RE: ERIE AIR PARK TRACT E DRAINAGE REVIEW

We have reviewed the Erie Air Park Tract E submittal received on December 2, 2019. The submittal included Minor Subdivision Binder including Phase III Drainage Report for Lot E-2 Erie Air Park Tract E dated October 11, 2019 and Construction Plans (Area Grading and Utility) dated November 8, 2019, by Nassar Development. A Planned Unit Development (PUD) Binder also included a Conceptual Site Plan dated November 8, 2019 by Nassar Development. We have the following comments to offer:

ERIE AIR PARK TRACT E-2 ~~Replat D~~

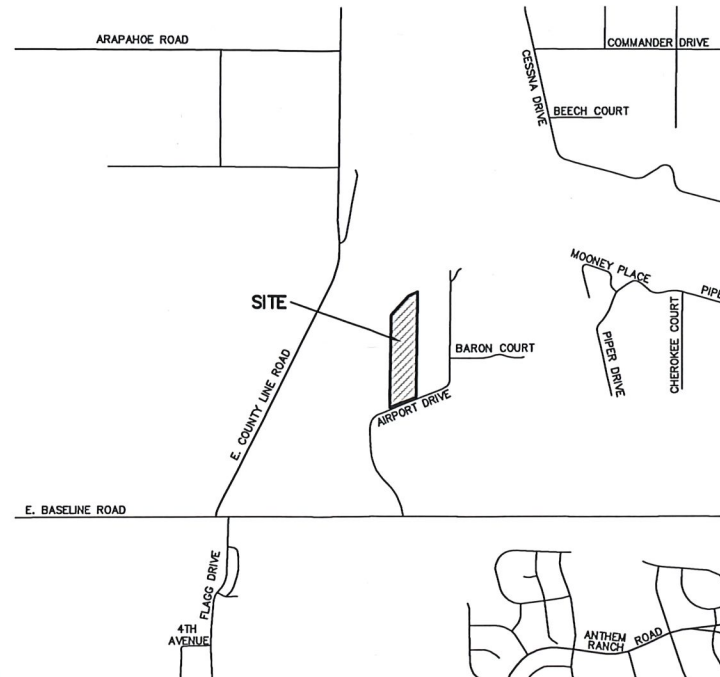
It says SW 1/4 on the plat. Correct either the plat or the PUD.

1 VICINITY MAP
SCALE: 1" = 5000'

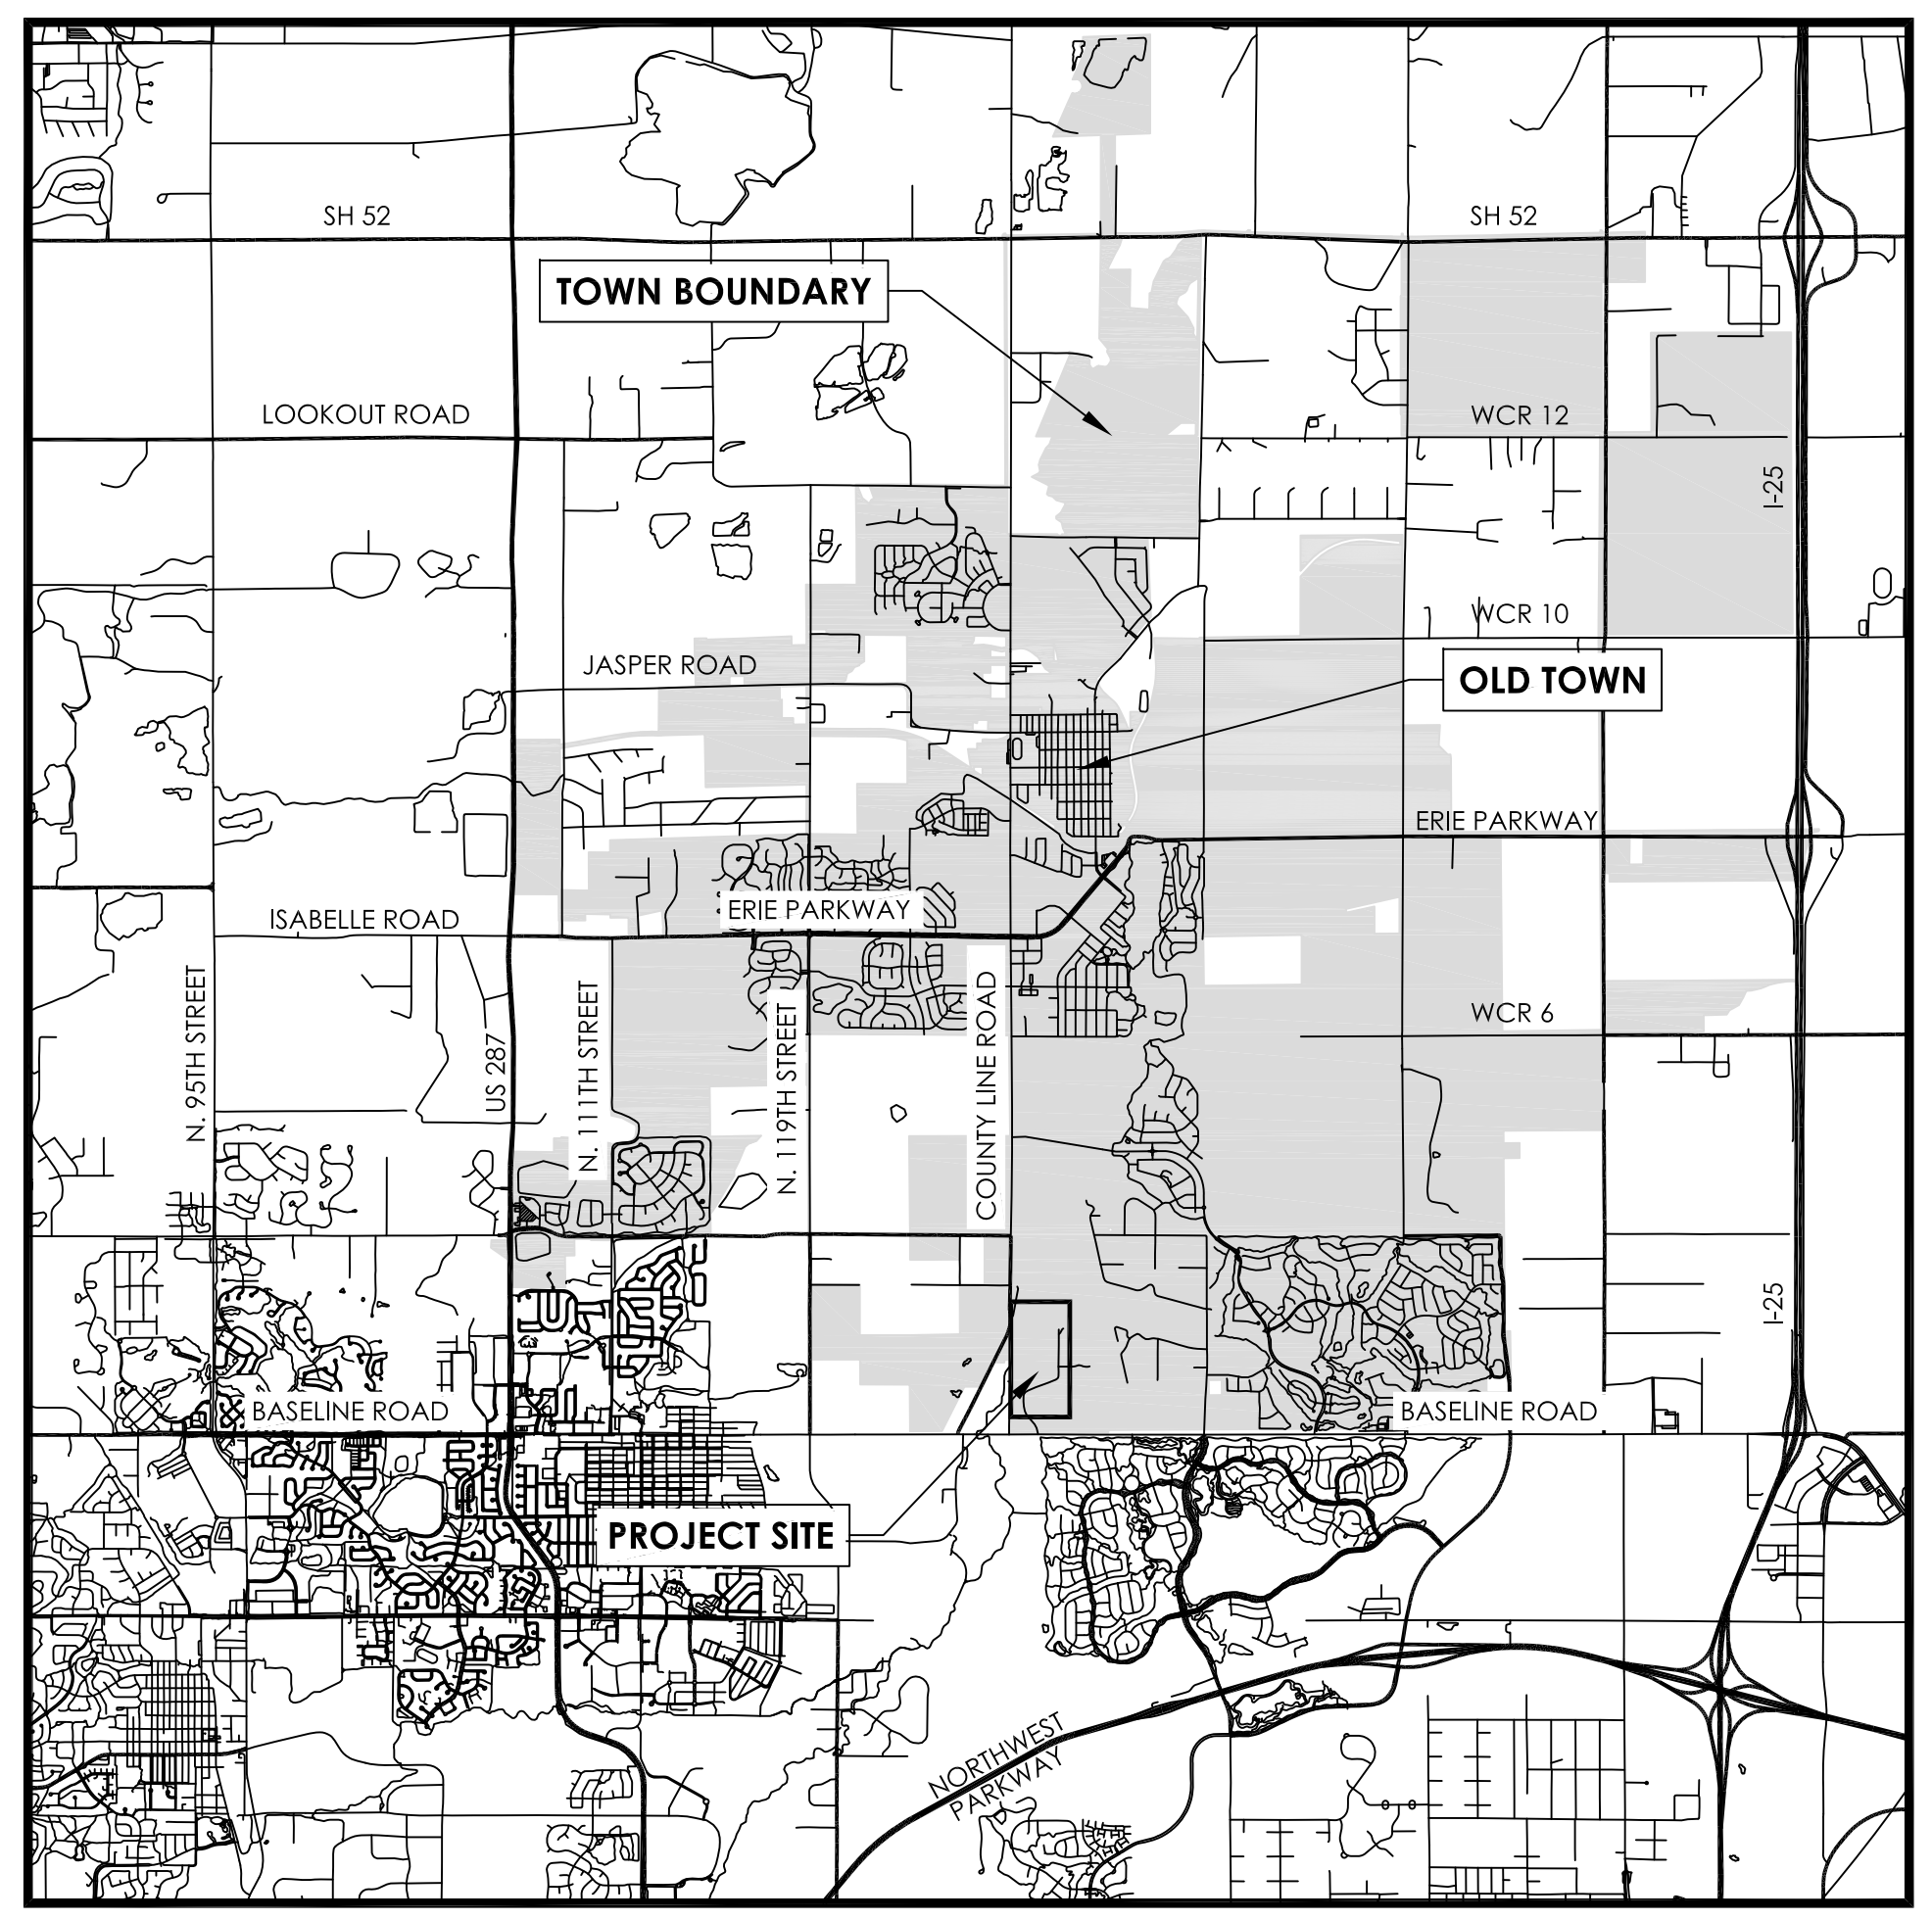
Add numbers.

Add a note stating: "In the event there is any discrepancy between the code and this PUD, the PUD shall control. Any provisions that are not specifically addressed in the approved PUD shall comply with the code."
